END OF ADDENDUM No. 01

JOB. TITLE: RENOVATIONS TO
GOVERNMENT OF CANADA BUILDING
ULUKHAKTOK, NWT

DWG. TITLE: ADDENDUM E-01
DRAWING E101
CELL FIXTURE LOCATION

DWN. BY: MAC	DES. BY: MAC	PROJ. MGR.: --
PEER REVIEW: JAK	DATE: (YY-MM-DD) 2013.05.30	SCALE: NTS
CLIENT PROJ. # WBSE # R.023085.001	WE PROJ. # 27574.00	OF 2 REV # A
DWG #		ESK-01

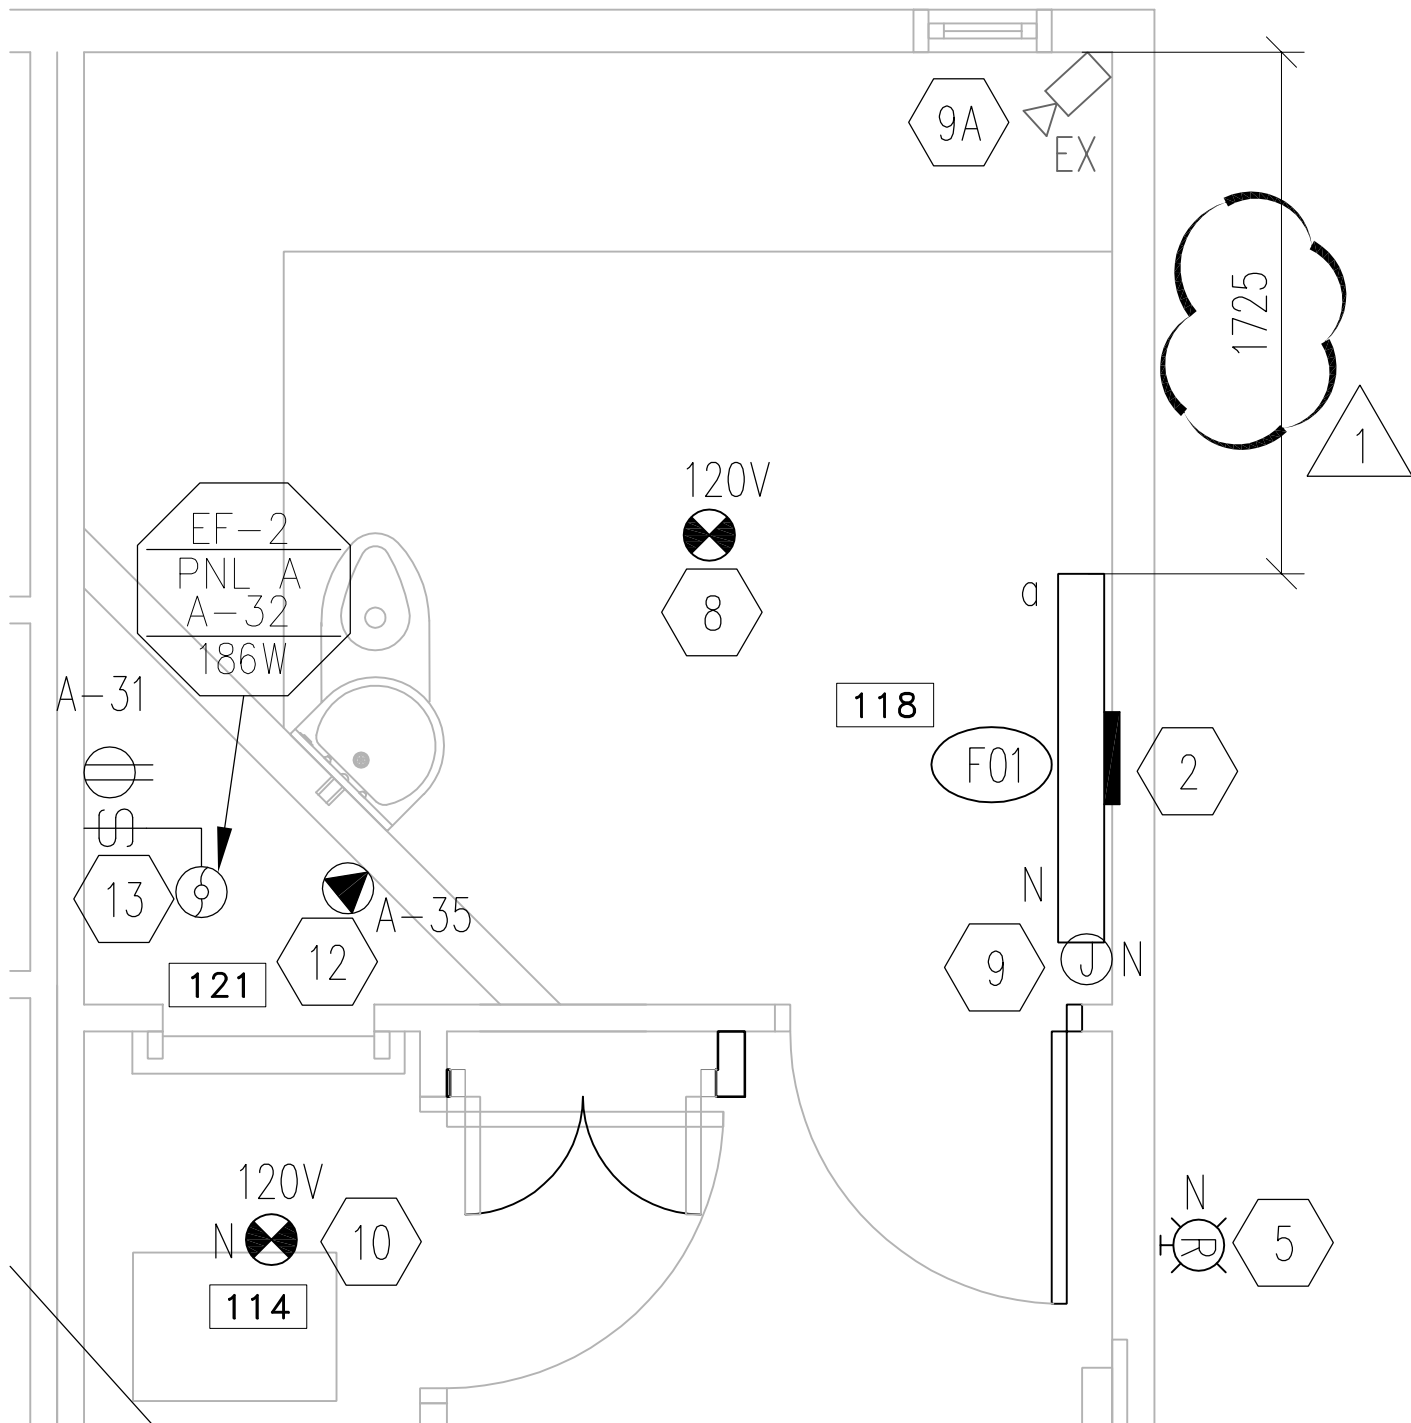
.1 Item: Cell light
Refer: Drawings: ESK-01 & ESK-02
Instructions: location of the Cell lights as noted and clarified – 1725 mm from exterior wall to rear edge of light fixture.
